Geotechnical Investigation

Proposed Industrial Redevelopment

135 Cardevco Road
Carp, Ontario

Report PG6018 -1 Revision 8 dated April 15, 2025

Figure 2 - Retaining Wall Cross Section Location

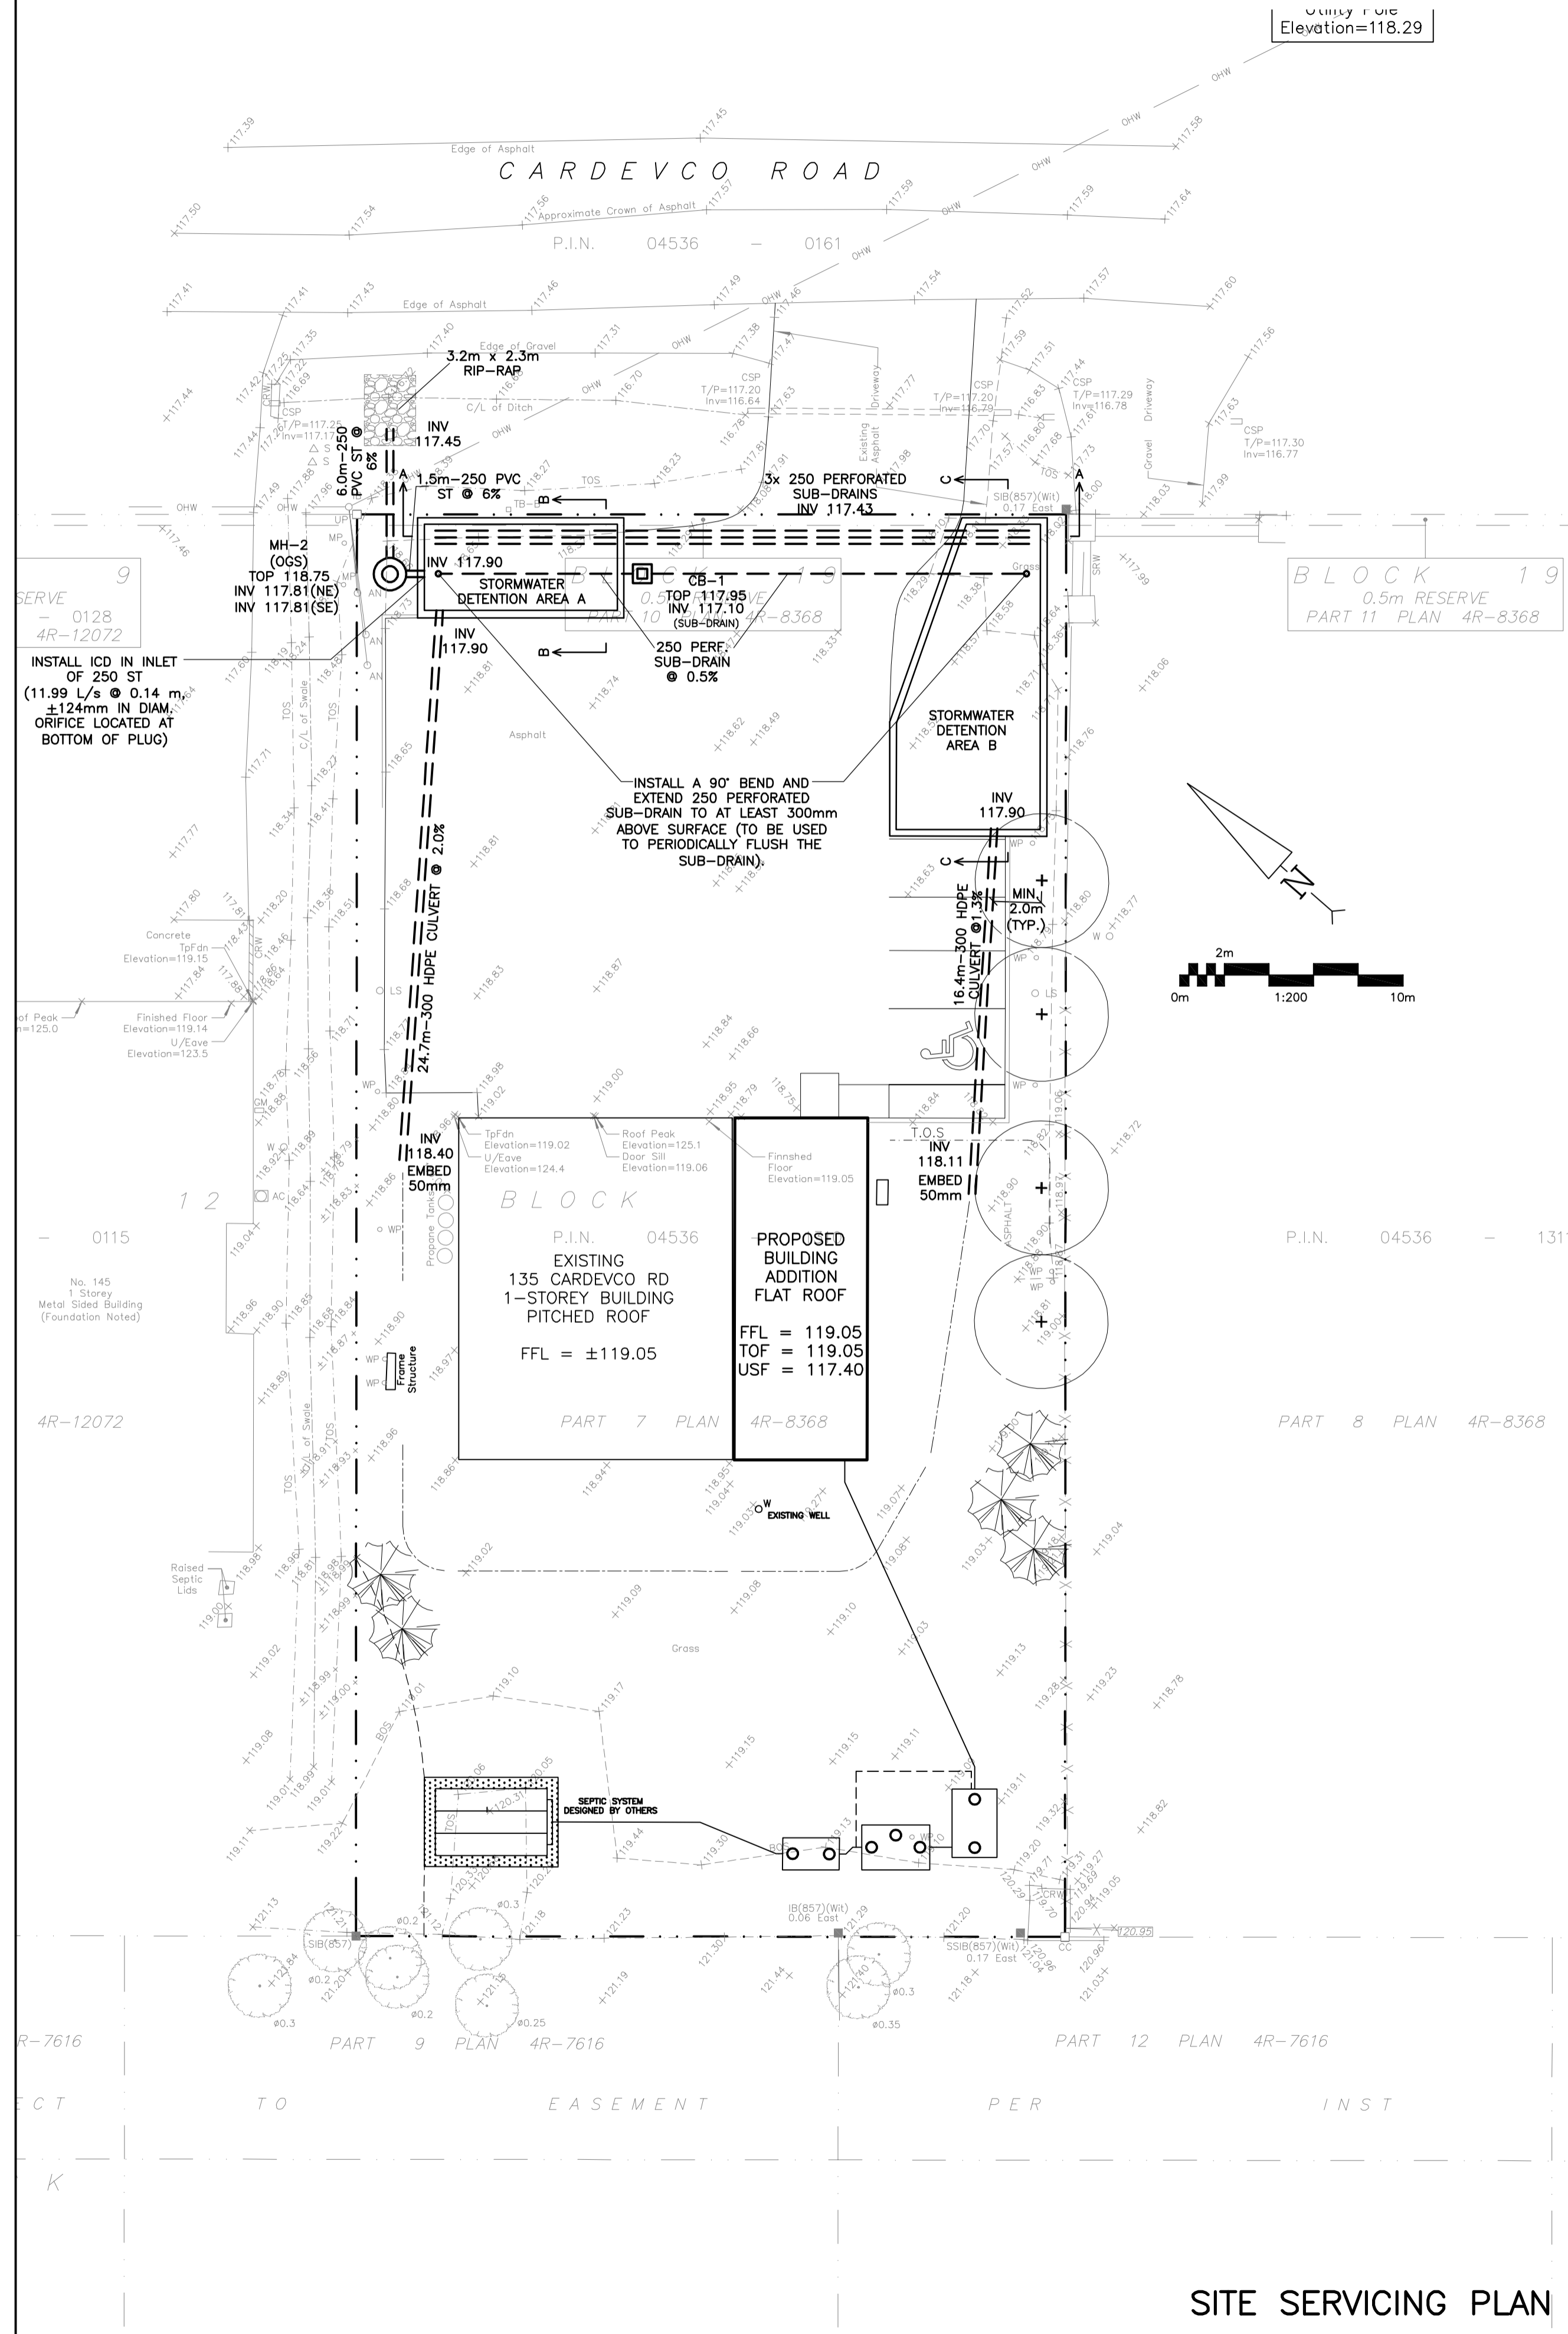
Comment 8.b: *The Geotechnical report prepared by Paterson Group Inc., dated November 24, 2023; Revision 4, requires a 1H:1V slope from the ground surface to the bottom of the retaining wall or a minimum of 1m setback from the back of the wall, for a proper placement and compaction of the backfill material.*

This requirement appears not to have been met for either of the two infiltration trenches. Please provide dimensions between the SWM features and the adjacent property lines on the Servicing & Grading Plan to confirm the required backfill set-back design requirements. Please also coordinate with the Arbaum architects who prepared the Stormwater Detention retaining Wall Details Plan (S300), which shows the distance to the property line, as 1 foot and 0 inches.

If the retaining wall geotechnical backfill requirement of a minimum 1 m cannot be accommodated within the property and a conventional construction 1:1 slope offset for placement of the OGS, then encroachment agreements with the affected adjacent property owners will be required, prior to the Site Plan Control approval.

Comment 10.b: *Cross-Sections show setback behind the retaining walls between 0.15 m – 0.35 m. Please see the comments above pertaining to the minimum backfill requirement and impacts to the adjacent properties.*

Response: This comment has been acknowledged. Please refer to the updated geotechnical report mentioned above. Alternative backfill materials have been proposed in cases where there is a limited setback between the proposed retaining wall and the property line.

Response: Reference should be made to our response to Comment 8.b in the current memorandum.
